Models 200/8, 220/8 and 250/8

The rocker arm bearing on engines for Models 200/8, 220/8 and 250/8 have been modified. The new version comprises the threaded bolt 130 055 01 74 and the ball pin 130 055 01 21. This modification results in a few facts which must be observed when walking on rocker arm bearings.

Fig. 05-4/1

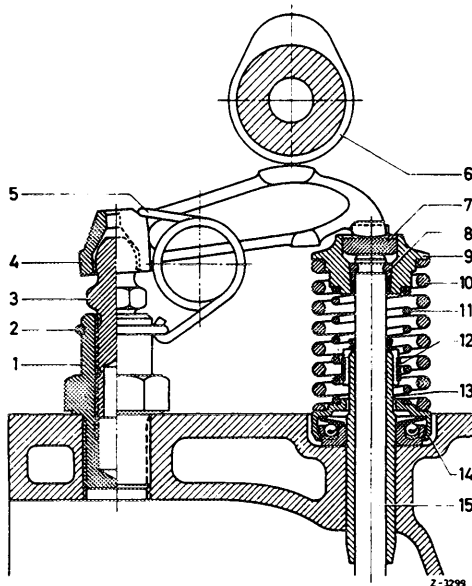
There is also a possibility that the ball pin will become seated in threaded bolt, so that the specified valve clearance cannot be adjusted (Fig. 05-4/5). This border case can be repaired by exchanging the thrust piece (Item 7, Fig. 05-4/1). Production

engines were provided with thrust pieces 4.5 mm thick, but they are also available 3.5 mm and 2.5 mm thick (for Part No. refer to spare parts catalogs).

Fig. 05-4/4

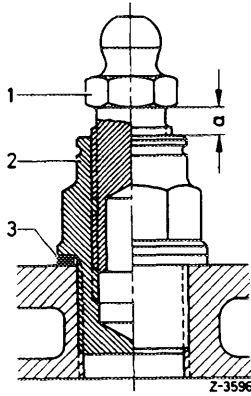
If the specified torque is not attained even when using a new threaded bolt because the ball pin must be screwed out too far, add a washer (self-made 2 mm thick at base of threaded bolt (Item 3, Fig. 05-4/4).
